Access Compliance Report

Public Rights-of-Way

Intersection ID: 22038	Main Street: DELPOND_LN	Cross Street: MIRABELL_RD	Location: E
ADA ID: 660425E7160F	Ramp Type: PerpDiag	Initial Pass/Fail: Fail	Overall Compliance: No
Codes/Mitigation Info/Possible Solution		Field Measurements/Component Compliance	
Severity Score: 33.75

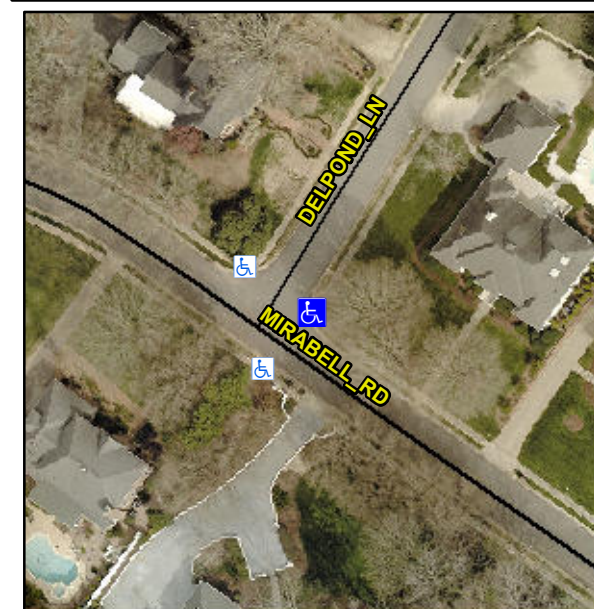
Not Found, R304.5.1, R304.5.3

Compliance	Description	Data	Compliance	Description	Data
N/A	Ramp Length (in)	51.0	Yes	Ramp Slope (%)	7.3
No	Ramp Width (in)	41.5	No	Ramp XSlope (%)	14.9
N/A	Flare Type LT	N/A	N/A	Flare Type RT	N/A
N/A	Flare Slope LT (%)	N/A	N/A	Flare Slope RT (%)	N/A
N/A	Flare Traversable LT?	N/A	N/A	Flare Traversable RT?	N/A
N/A	Landing Length (in)	N/A	N/A	DWS Provided?	N/A
N/A	Landing Width (in)	N/A	N/A	DWS Contrast?	N/A
N/A	Landing Slope (%)	N/A	N/A	DWS Length (in)	N/A
N/A	Landing X Slope (%)	N/A	N/A	DWS Full Width?	N/A
N/A	Landing Curb? (Y/N)	N/A	N/A	DWS Offset (in)	N/A
N/A	Shared Landing?	N/A			
N/A	Gutter Ponding?	N/A	N/A	Gutter Slope (%)	N/A
N/A	Gutter Lip Ht (in)	N/A	N/A	Gutter X Slope (%)	N/A
N/A	Painted X Walk1?	No	N/A	Painted X Walk2?	No
	X Walk 1 Direction	To NW		X Walk 2 Direction	To SW
N/A	X Walk 1 Width (in)	N/A	N/A	X Walk 2 Width (in)	N/A
	X Walk 1 Slope (%)	6.2		X Walk 2 Slope (%)	0.6
	X Walk 1 X Slope (%)	7.8		X Walk 2 X Slope (%)	8.0

Remove & Replace Curb Ramp With Two New Directional Ramps or Equivalent.
